## **Bi-weekly Seismic Call Minutes**

**Date:** 2016-05-03

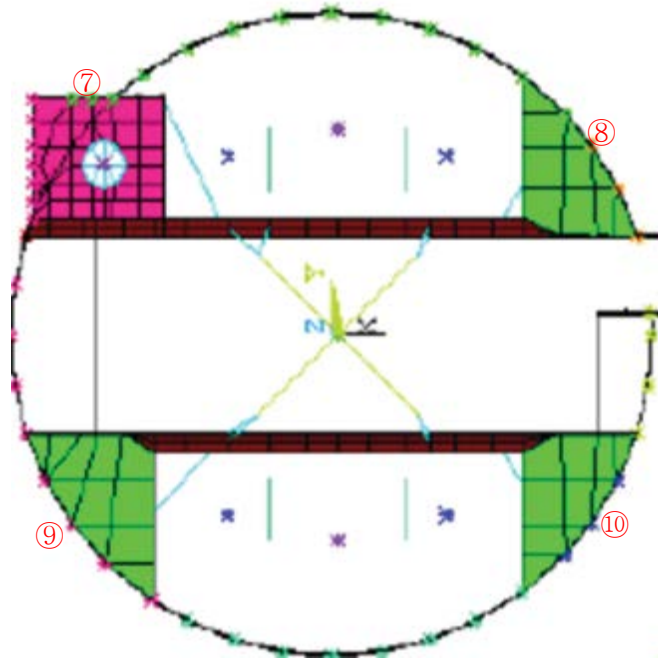
KHNP is to determine what slabs have been included in the live load study, re-perform the study if all slabs have not been included, and revise the RAI response to describe the modeling of all slabs and discuss the treatment of live loads with regard to those slabs (justify if excluded).

The main issue that the NRC has is that the adequacy of the reactor containment walls is discussed, but the slab also needs to be addressed. Specifically whether the slab is considered flexible or rigid and if flexible, how is it determined that the mesh is adequate for the increased frequency response? How is out-of-plane behavior addressed in the modeled and non-modeled cases?

There are some small horizontal surfaces in the reactor containment building other than those horizontal surfaces between the secondary shield wall (SSW) and the containment shell. The small horizontal surfaces which are not between the SSW and the containment shell are modeled in the reactor containment building seismic analysis model. The following figure shows the horizontal surfaces modeled in the reactor containment building seismic analysis model compared to those those horizontal surfaces shown in DCD Tier 2, Figure 1.2-2, "General Arrangement Reactor Containment Building Section A-A"

In addition to the six horizontal surfaces shown in the figure above, four horizontal surfaces also exist in the reactor containment building, as shown in the figure below.

Since the ten horizontal surfaces labeled above are relatively small, the seismic live loads of those surfaces were ignored in the last study for evaluation of seismic live load effect on seismic response of the reactor containment building.

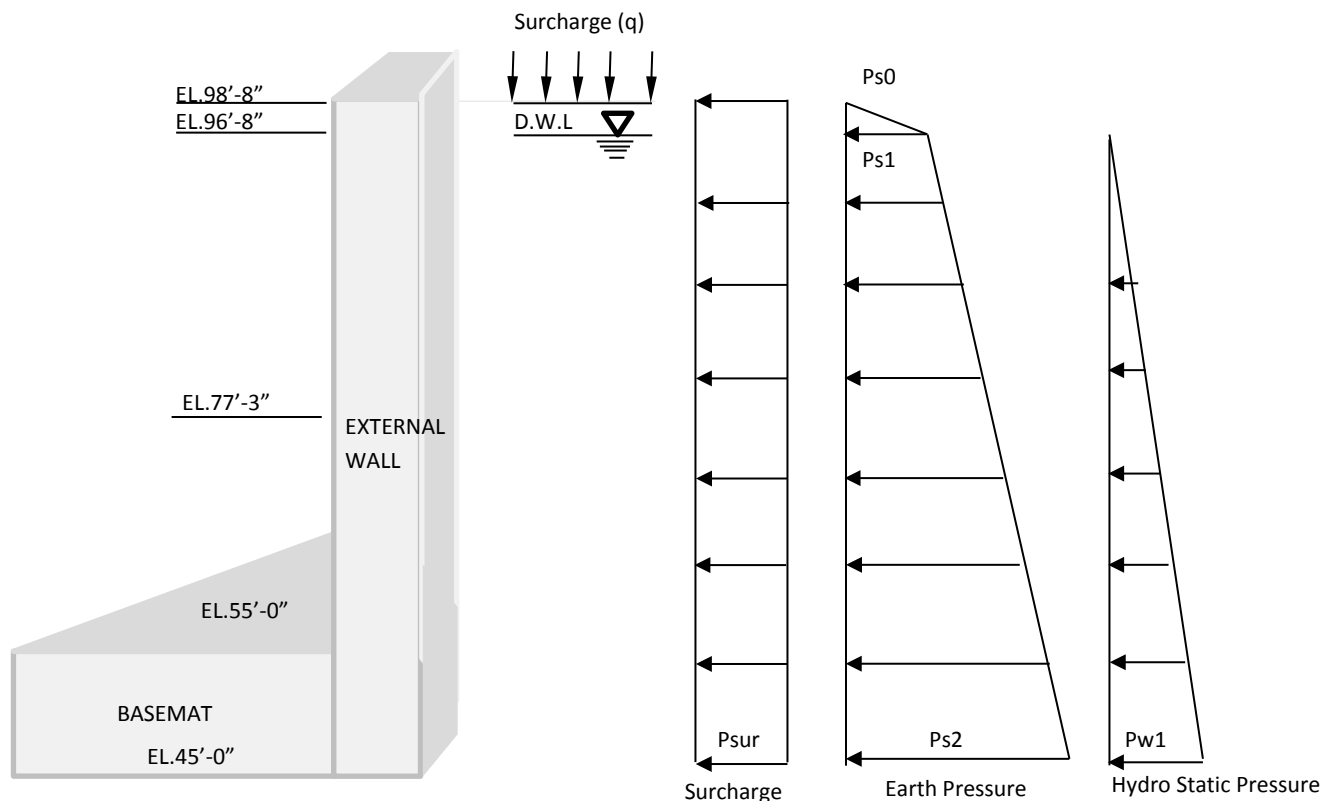
KHNP is to provide the revised response which includes the EDGB & DFOT.

KHNP is experiencing technical challenges. An investigation of how previous applicants have resolved contact ratio issues is underway. KHNP anticipates being able to provide a draft due date during the next bi-weekly call on 2016-05-18.

The staff reiterated that they agree with the methodology used for the nuclear island and expects that the same be used for the EDGB and DFOT. They understand that the technical challenges have been resolved and will look forward to reviewing the draft response soon.
